UNITED STATES PATENT AND TRADEMARK OFFICE

10/543,026

Office Action Summary	Application No. 10/543,026	Applicant(s) LEGRAND, EMMANUEL	
	Examiner GHASSEM ALIE	Art Unit 3724

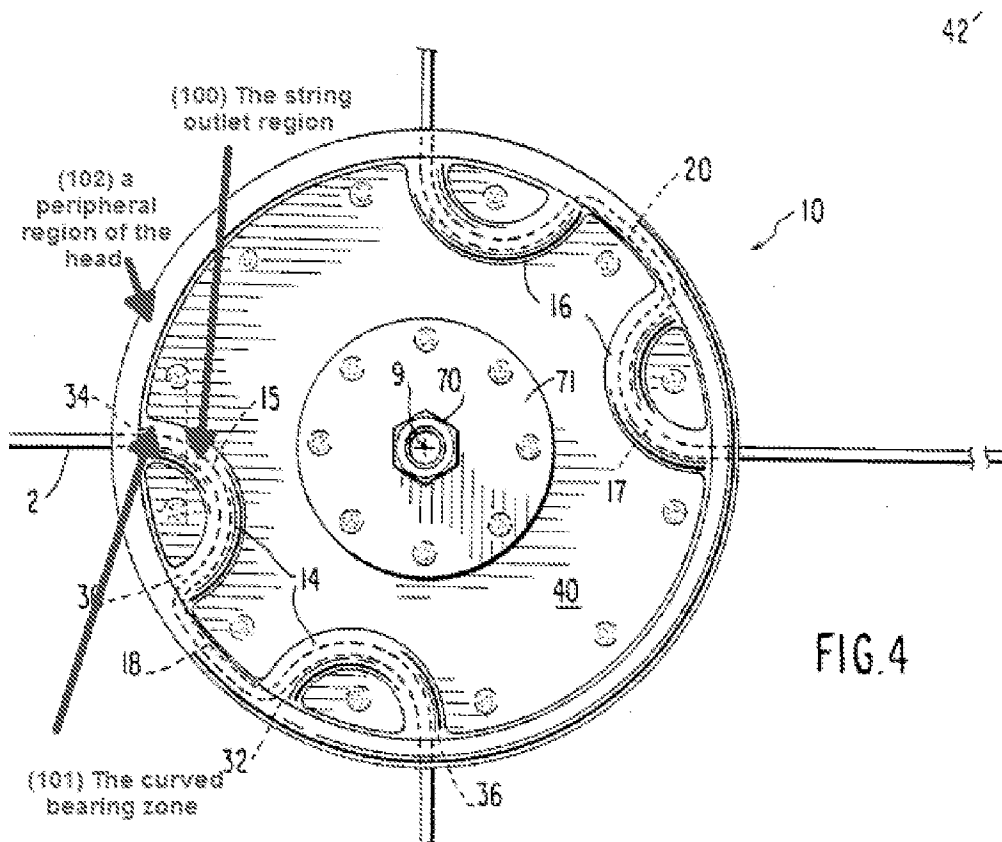
It should be noted that the string outlet region could be defined by the mid-section of the passage, and the curved bearing region could be considered as the region between the string outlet region to the periphery region of the head as show in Fig. 1 below. Rouse also teaches that a surface of the curved bearing zone presents a recessed profile 46 which is substantially complementary to a part of cross-section of the cutting string 2, in order to guide the cutting string in the recess when the string flexes in a direction opposite to the rotation of the head to rest against the curved bearing zone.

Applicant's argument that Rouse does not teach any bearing zones or any other features extending between the string outlet regions and the periphery of the head is not persuasive. As stated above, Rouse teaches at least one curved bearing zone 101 extending between a string outlet region 100 of the passageway and a peripheral region 102 of the head. It should be noted that the string outlet region could be defined by the mid-section of the passage, and the curved bearing region could be considered as the region between the string outlet region to the periphery region of the head as show in Fig. 1 above.
